CITY OF GLENDALE, CA

DESIGN REVIEW STAFF REPORT – MULTI FAMILY

July 11, 2024 <i>Decision Date</i>	1038 Irving Avenue <i>Address</i>
Administrative Design Review (ADR) <i>Review Type</i>	5624-012-001 <i>APN</i>
PADR-003134-2024 <i>Case Number</i>	Harry Akopian <i>Applicant</i>
Shoghig Yepremian, Planner <i>Case Planner</i>	Artour Babayans <i>Owner</i>

To construct a detached, two-story, 1,120 square-foot residential dwelling unit (Unit A) and a detached, two-story, 1,358 square-foot residential dwelling unit (Unit B) at the rear of an 8,222 square-foot lot developed with a 1,036 square foot single family dwelling (constructed in 1925), located in the R2250 (Medium Density Residential) zone. The existing single-family dwelling will remain on the site without modifications or changes. However, the existing non-conforming 341 square-foot detached garage servicing the single-family residence will be demolished to accommodate the construction of two proposed detached dwelling units at the rear.

1 Site Plan
1/8" = 1'-0"

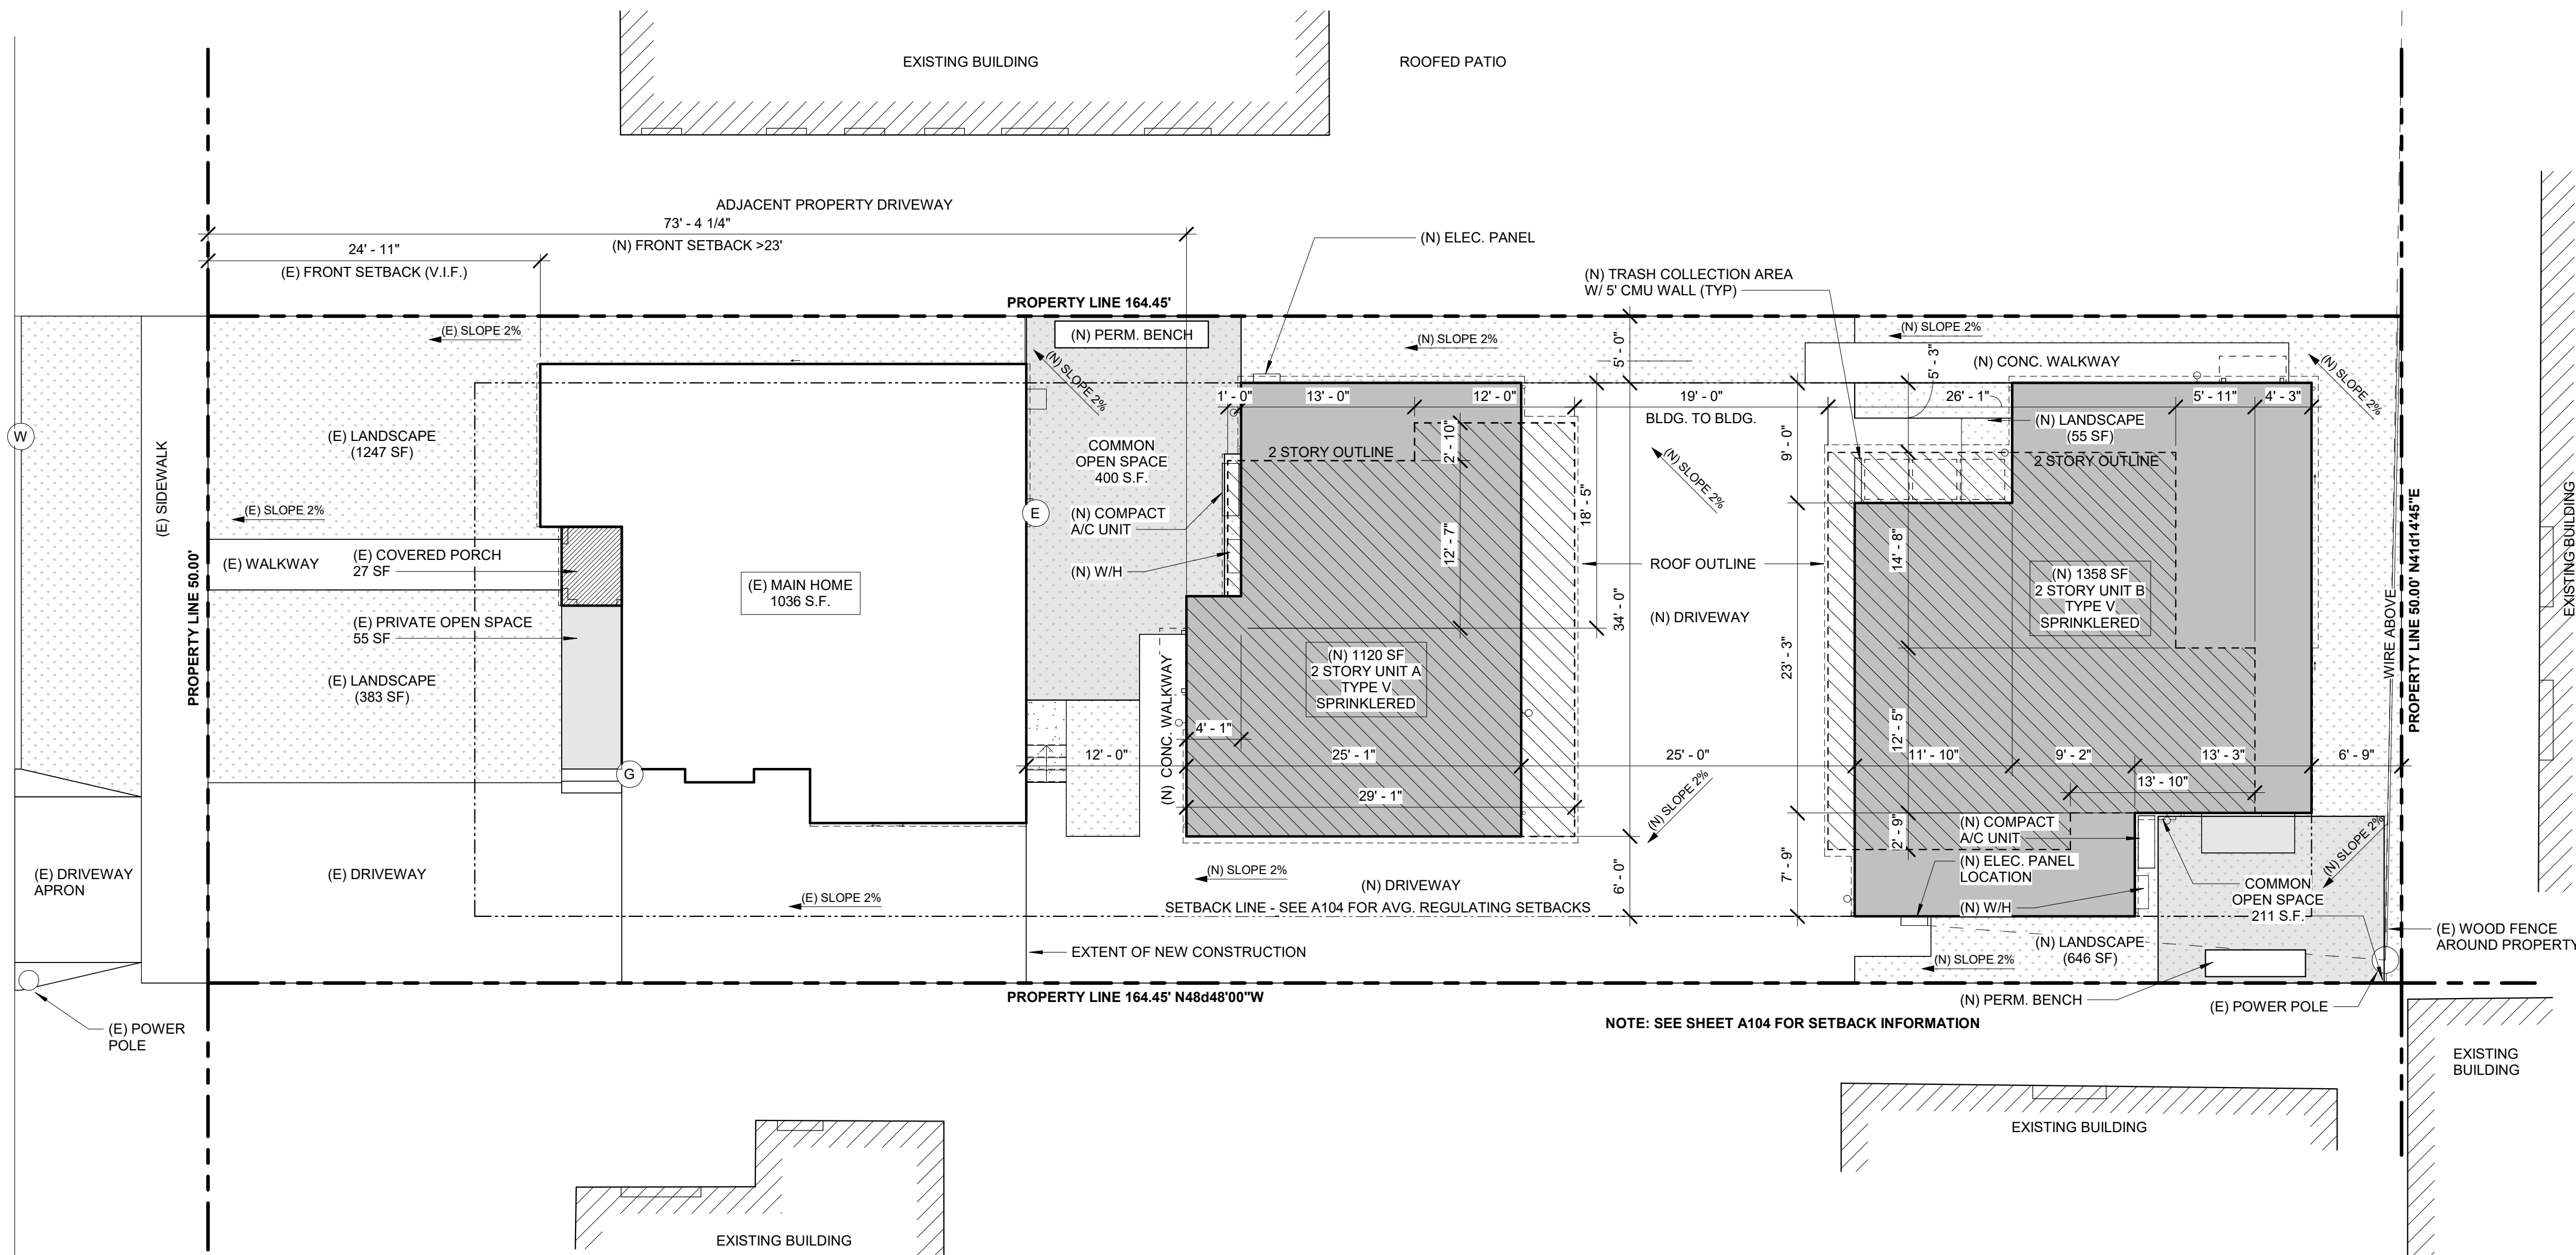
The plans show that the existing driveway will be maintained to access the parking spaces for the new units. However, the proposed driveway material shows as concrete. The Multi-Family Residential design guidelines suggest paving materials to include brick, stone, textured concrete, etc. A condition of approval is attached to recommend that the driveway paving material is consistent with the City’s Multi-Family Design Guidelines.

The project is proposing concrete paving for the driveway and walkways. The Multi-Family Residential Design Guidelines recommend the use of decorative paving treatments such as brick, pavers, stamped concrete to enhance curb appeal from the street.

- Include decorative paving materials for the driveway, walkways and common open space areas.
- Add siding at the second level gables to provide a variety of materials.
- The exterior stucco finish to have smooth finish throughout the units.

SHEET DESCRIPTION:
UNIT A - EXTERIOR ELEVATIONS,
SECTIONS

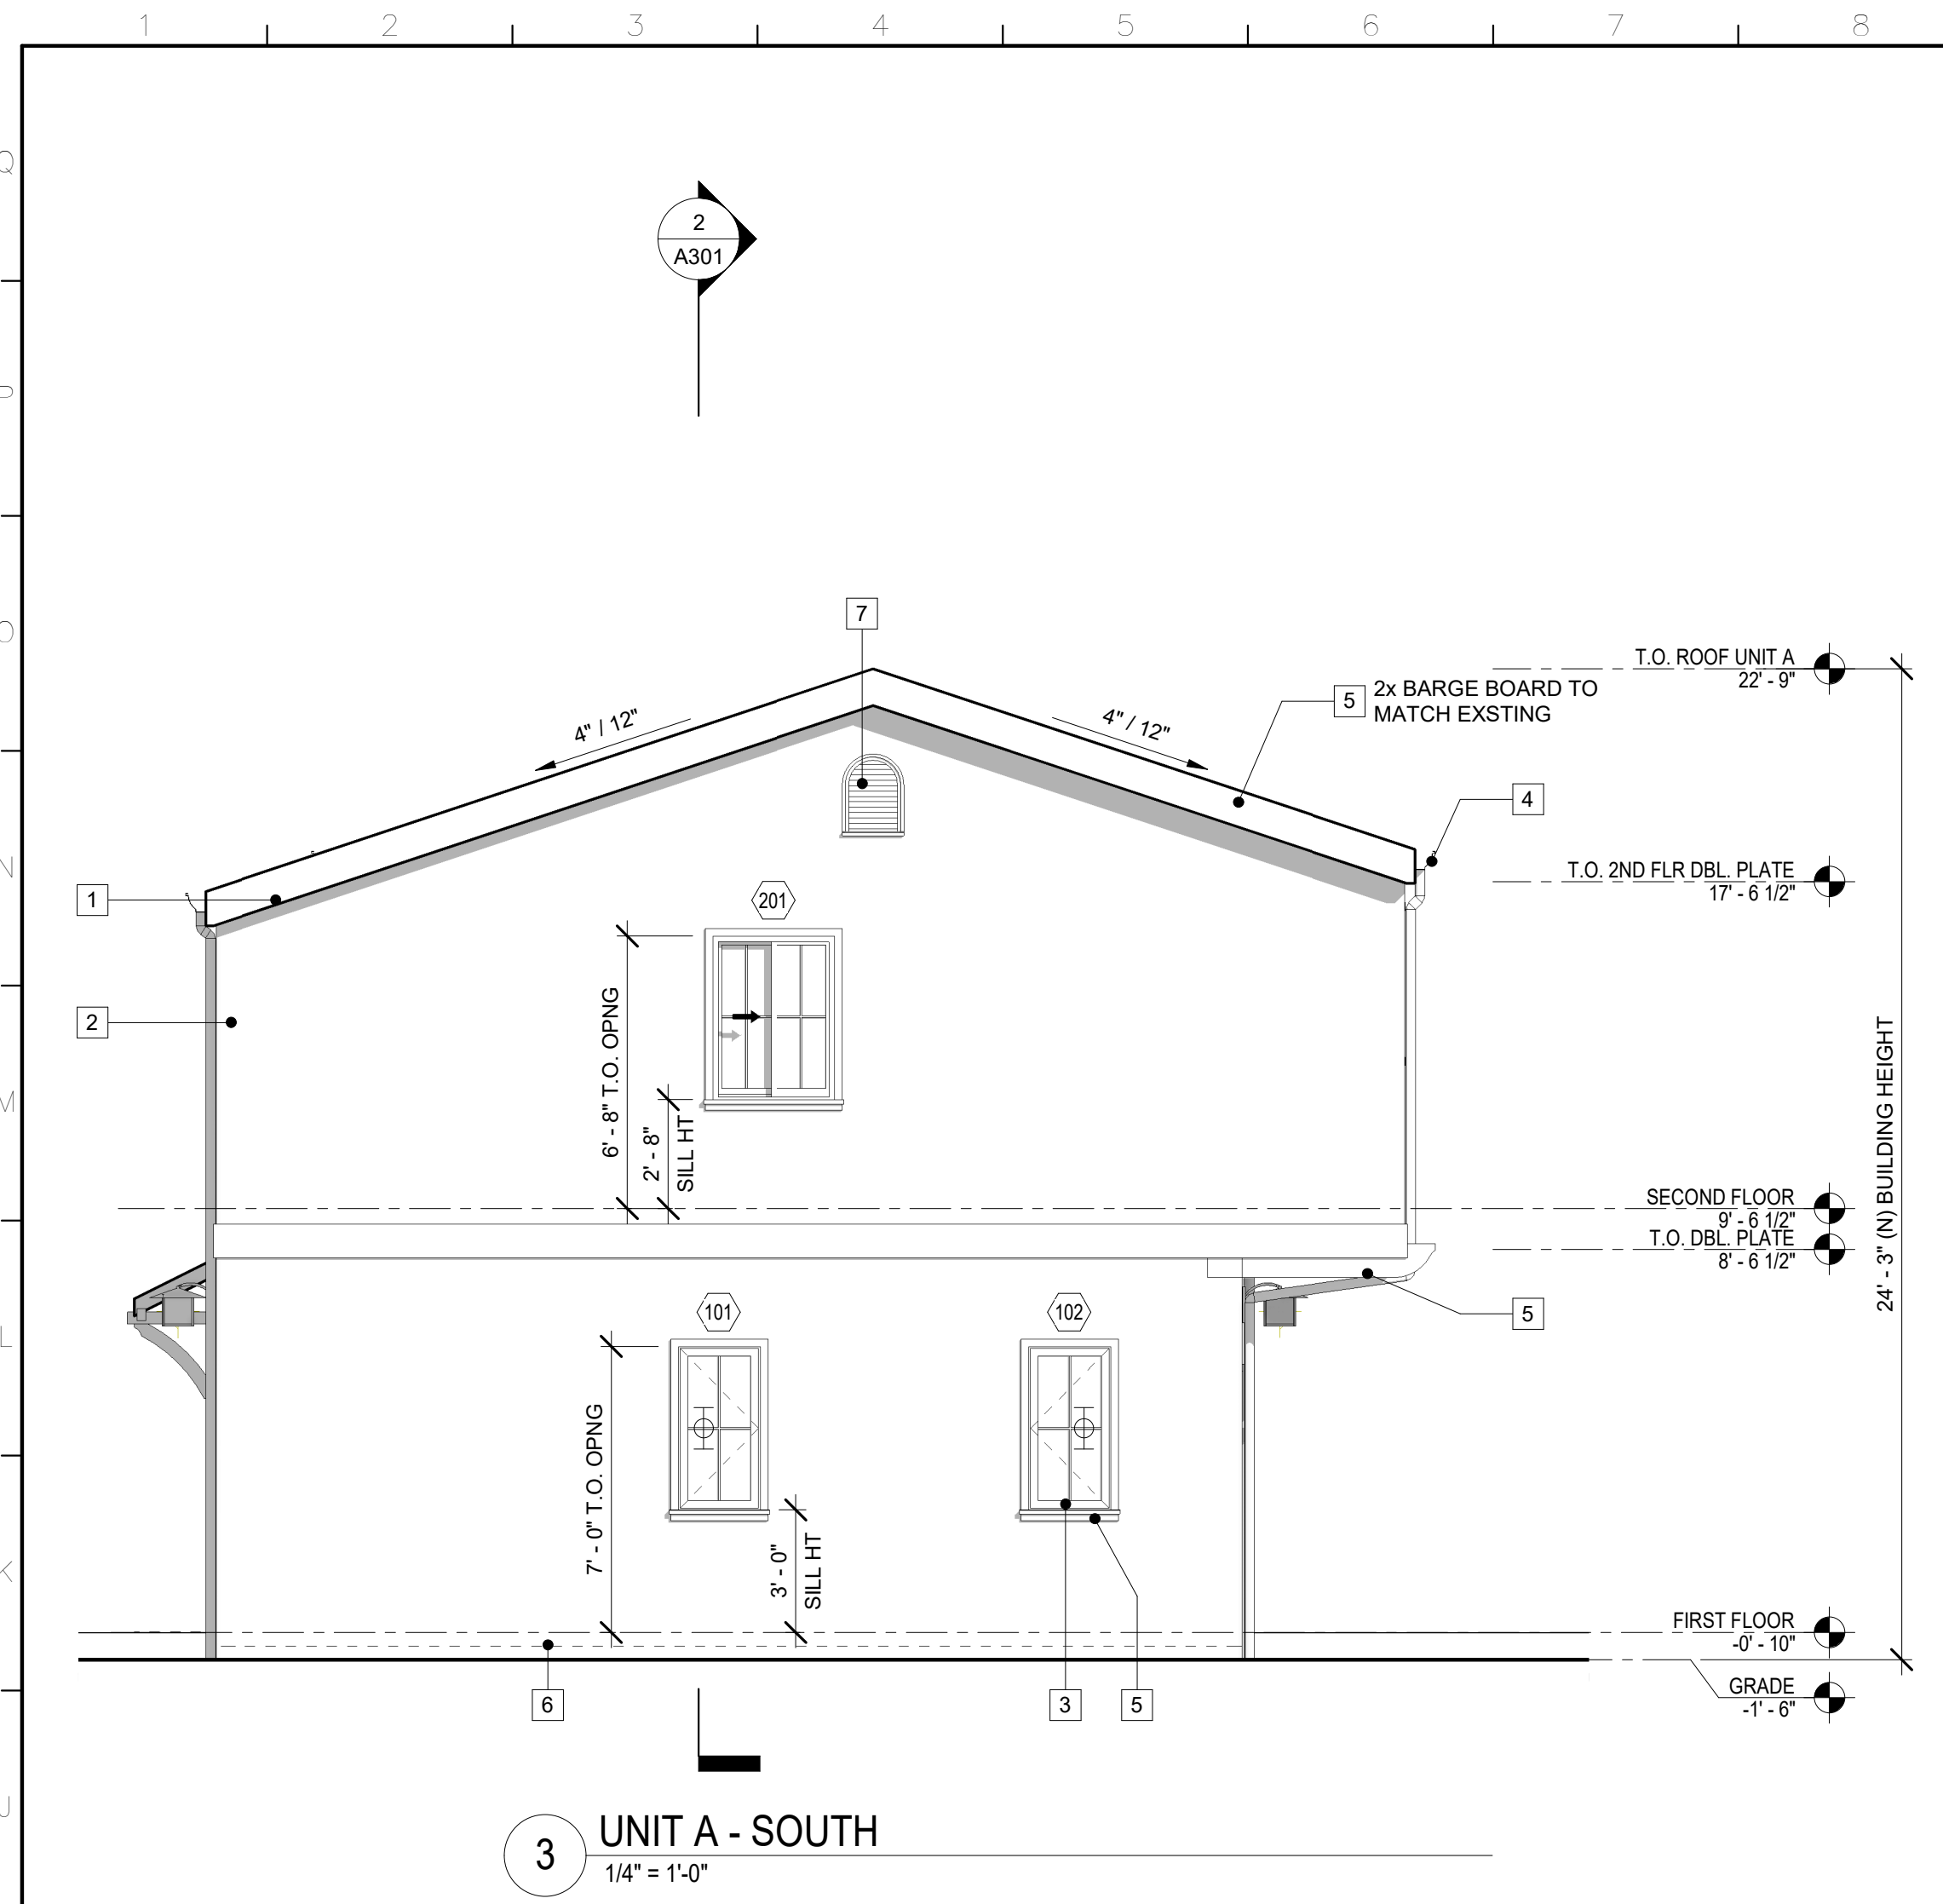
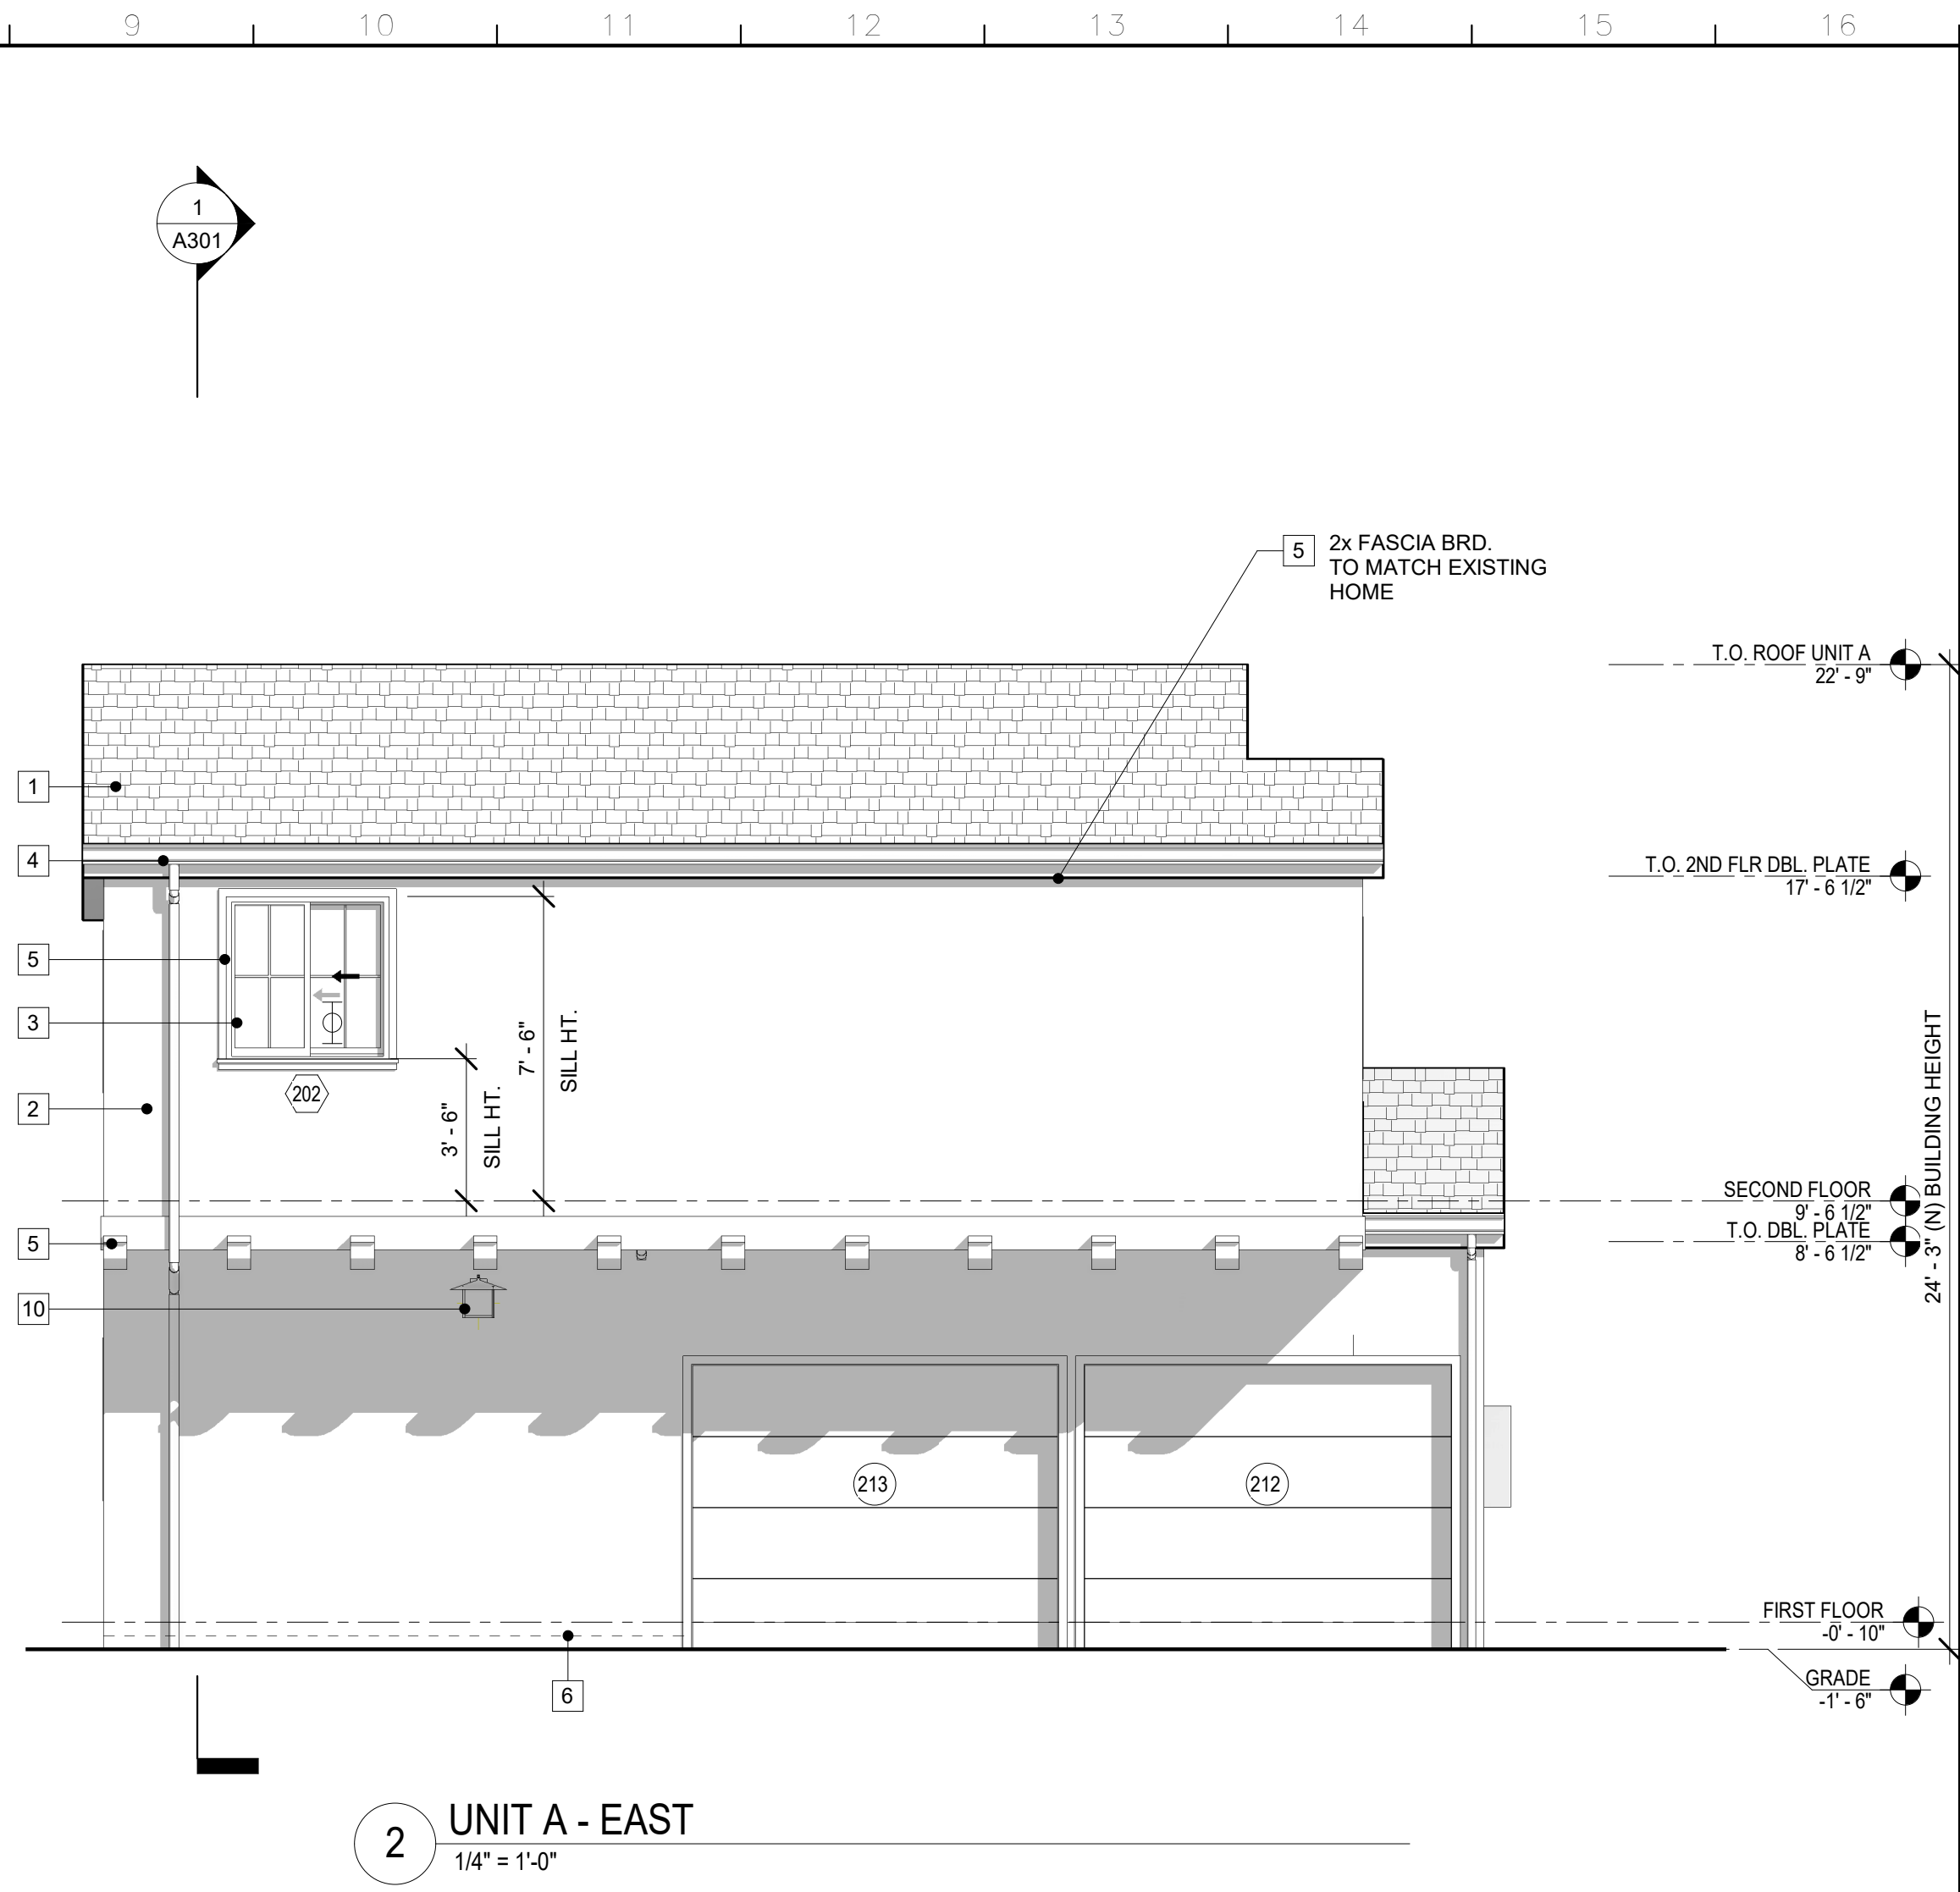
Both of the new units are located at the rear of the property and not in direct view from the street. The stucco finish for the new units will match the front house exterior color. Guidelines encourage a variety of materials in lieu of stucco alone. Staff recommends the application of sidings at the second level gables to provide a variety of materials.
